CELLULAR SERVICE Bulletin

CSB-1310-3
 Country : UK
 Date : 4/27/2007
 APC : ALL
 Repair Level : 3

Title W220 - GSM - SIM card - Card holder broken issue
 Model Effected Sicily

Picture 1

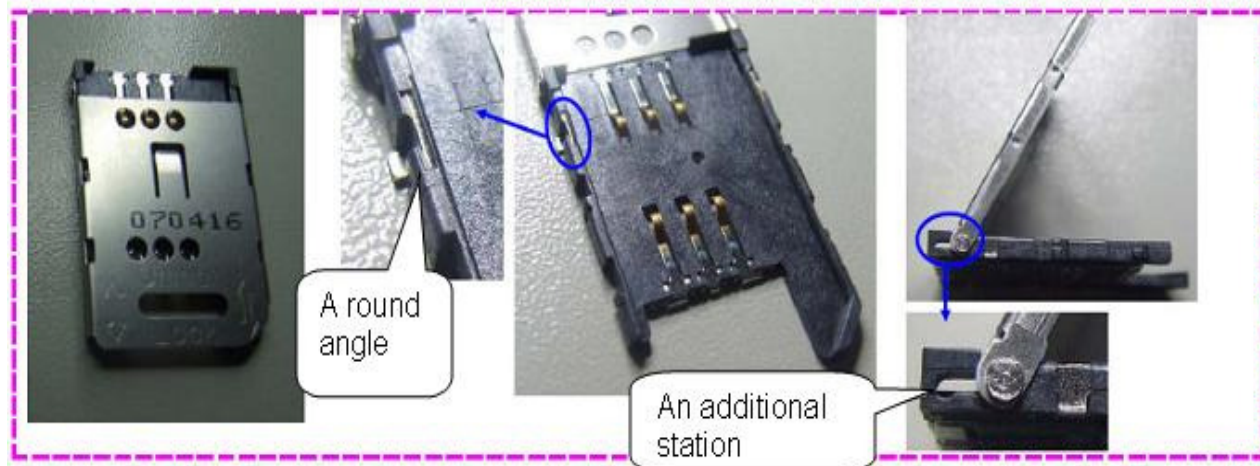
Service is aware of an issue, identified in GSM W220 MOL analysis, with customer returns complaints of "SIM card - Card holder broken".

The root cause analysis identified that there is interference between the housing and the shell inner corner of SIM connector causing no solder on the SIM connector.

- 1- Please check if the failure symptom is according to the picture 1 above;
- 2- If yes, replace the original SIM connector with a new one.
- 3- If not, please proceed to normal troubleshooting techniques.

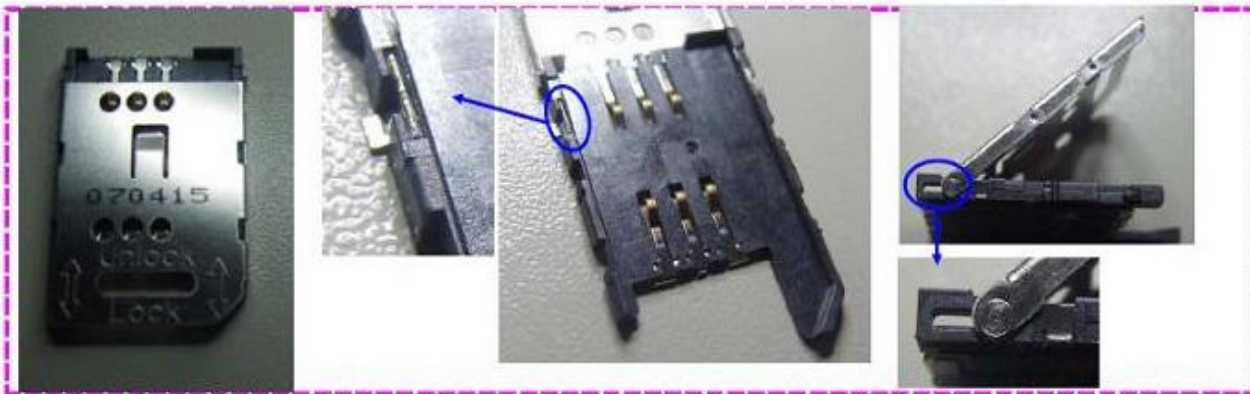
SIM connector PN MESC47002B was redesigned to modify the angle of housing to R 0.40mm according to the picture below.

New Housing

Old Housing

The corrective action was implemented on SIM socket date code after 070416.
